PACKARD

Service Counselor

VOL. 22, NO. 14

DECEMBER 1, 1948

New Type Differential Gears and Pinions

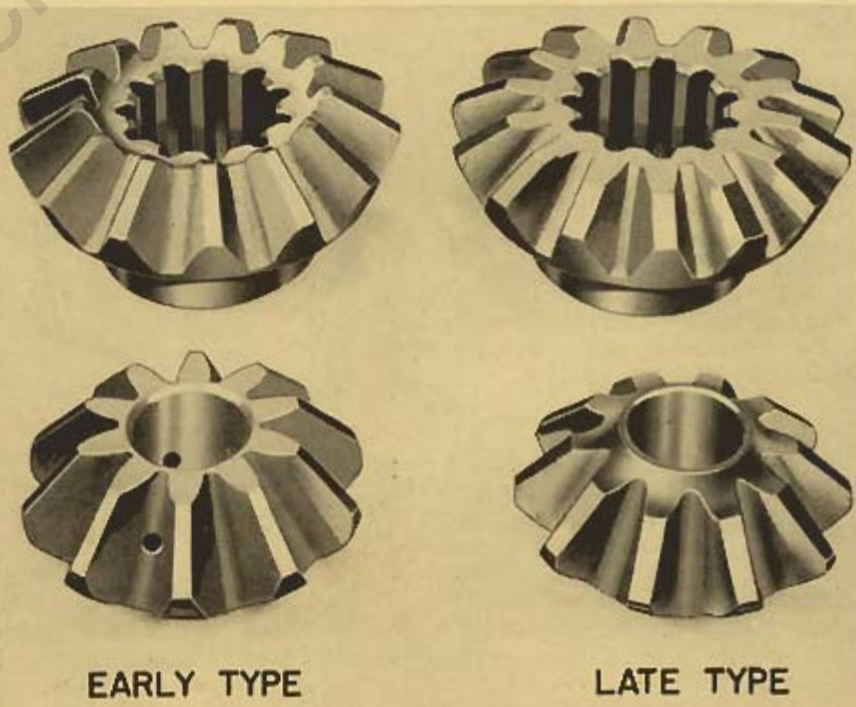
The accompanying illustration shows the differences between the early type and the new type gears and pinions.

The front face of the early type differential gear is counterbored and has 13 teeth, while the new type gear has a flat face and 14 teeth. The early type differential pinion has a flat face and 3 drilled oil holes. The new type pinion has an undercut face and no oil holes.

When it is necessary to replace gears and pinions, make certain that the correct parts are being ordered as these new parts are not interchangeable with the early type.

The early type gears and pinions should be ordered under the part numbers listed in the Parts List. The new parts are available under the following part numbers: 403057 — Rear Axle Differential Pinion; 403058 — Rear Axle Differential Gear.
